UNITED STATES PATENT AND TRADEMARK OFFICE

APPLICATION NO.	FILING DATE	FIRST NAMED INVENTOR	ATTORNEY DOCKET NO.	CONFIRMATION NO.
10/026,477	12/27/2001	Hong Suk Yoo	8733.561.00	7762
30827	7590	12/28/2005		
MCKENNA LONG & ALDRIDGE LLP 1900 K STREET, NW WASHINGTON, DC 20006			EXAMINER RUDE, TIMOTHY L	
			ART UNIT	PAPER NUMBER
			2883

Office Action Summary

DETAILED ACTION

FIG. 8D

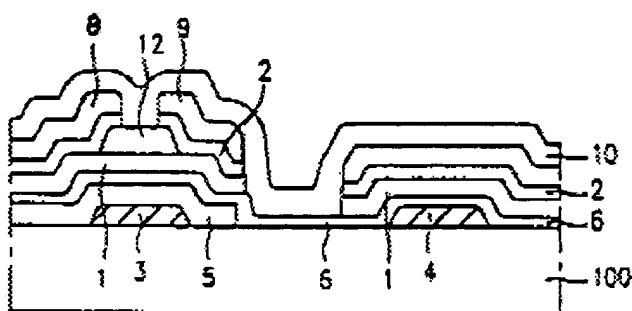
As to claim 15, Moon discloses in the 5th embodiment (col. 6, lines 8-63 and Figures 8A-8D) a liquid crystal display (LCD) device comprising:
a first substrate , 100; a second substrate;
a liquid crystal layer formed between the first and second substrates;
a storage capacitor, (combination of 4, 6, 1, 2, and unlabeled 9; col. 6, lines 10-30),
formed in a first region of the first substrate;
a thin film transistor formed in a second region of the first substrate.

a gate electrode, 3, for the thin film transistor and a storage capacitor electrode, 4, spaced apart from the gate electrode, both formed on the first substrate;

a first insulating layer, 5, formed on the overall surface [col. 4, lines 1-13] of the first substrate [Applicant's formed on an entire surface of the first substrate];

a second insulating layer, 6, formed on the first insulating layer and the storage capacitor electrode;

a conductive layer (unlabeled layer between layers 2 and 10 above 4) formed on the second insulating layer overlapping the storage capacitor electrode in the first region;

a pixel electrode (not shown, inherent to comprise functional device) electrically connected to the conductive layer and a drain electrode, 9, on the thin film transistor.

Moon does not explicitly disclose removing a first insulating layer, 5, formed on an entire surface of the first substrate exclusively from an upper portion of the storage capacitor electrode. However, the teachings of Moon are considered to render the claimed invention obvious to those having ordinary skill in the art of liquid crystals, since there is no disclosed functional significance to the minor structural difference as claimed in either Moon or Applicant's enabling disclosure.

As to claim 17, Moon discloses in Figure 8D the liquid crystal display device as claimed in claim 15, further comprising a semiconductor layer, 1, formed above the second insulating layer in the second region and used as a channel of the thin film transistor.

As to claim 18, Moon discloses in Figure 8D the liquid crystal display device as claimed in claim 17, further comprising a source electrode, 8, and a drain electrode, 9, opposing each other and formed above the semiconductor layer.

As to claim 19, Moon discloses in Figure 8D the liquid crystal display device as claimed in claim 18, wherein the conductive layer (unlabeled 9 between 2 and 10) is of the same material as the source and drain electrodes and formed on the second insulating layer in the first region.

As to claim 20, Moon discloses in Figure 8D the liquid crystal display device as claimed in claim 18, further comprising an ohmic contact layer, 2, formed at an interface between the source and drain electrodes and the semiconductor layer.

As to claim 21, Moon discloses in Figure 8D the liquid crystal display device as claimed in claim 18, further comprising a passivation layer, 10, having a contact hole and formed on an entire surface including the conductive layer and the source and drain electrodes to expose upper portions of the drain electrode and the conductive layer.

As to claim 22, Moon discloses in Figure 8D the liquid crystal display device as claimed in claim 21, wherein the pixel electrode electrically connects to the drain electrode and the conductive layer through the contact hole (inherent to a functional device and obvious to those having ordinary skill in the art given the other embodiments of Moon).

FIG. 2

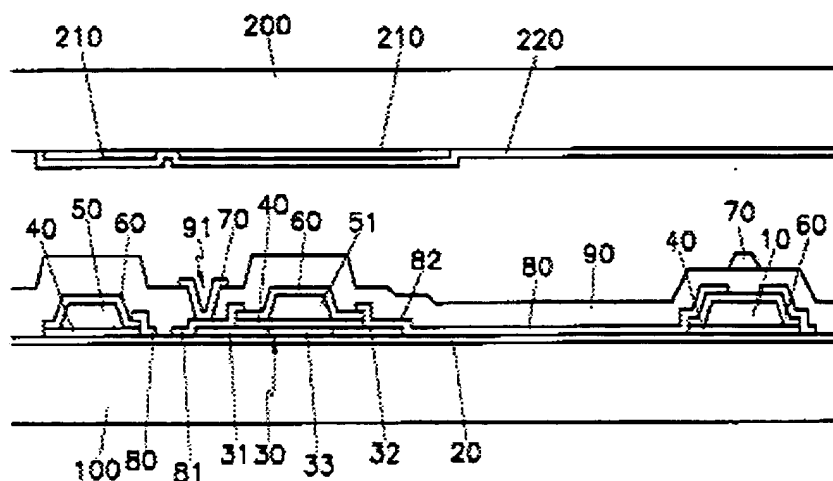
For example, Hwang teaches in the background of the invention, and in the first preferred embodiment, a second substrate, 200, comprising a plurality of Red (R), green (G), and blue (B) color filter patterns (col. 1, lines 26-33 and col. 2, lines 22-28; and Figure 2) for displaying colors; a black matrix, 210, for dividing the respective color filter patterns and for shielding light; and a common electrode, 220, for applying a voltage to the liquid crystal layer formed on the entire surface (col. 3, lines 24-26) including the black matrix and the color filter patterns, to achieve good color display performance with good contrast and good aperture ratio.

Hwang is evidence that ordinary workers in the art of liquid crystals would find the reason, suggestion, or motivation to add a second substrate comprising a plurality of Red (R), green (G), and blue (B) color filter patterns for displaying colors; a black matrix for dividing the respective color filter patterns and for shielding light; and a common electrode for applying a voltage to the liquid crystal layer formed on the entire surface including the black matrix and the color filter patterns, to achieve good color display performance with good contrast and good aperture ratio.
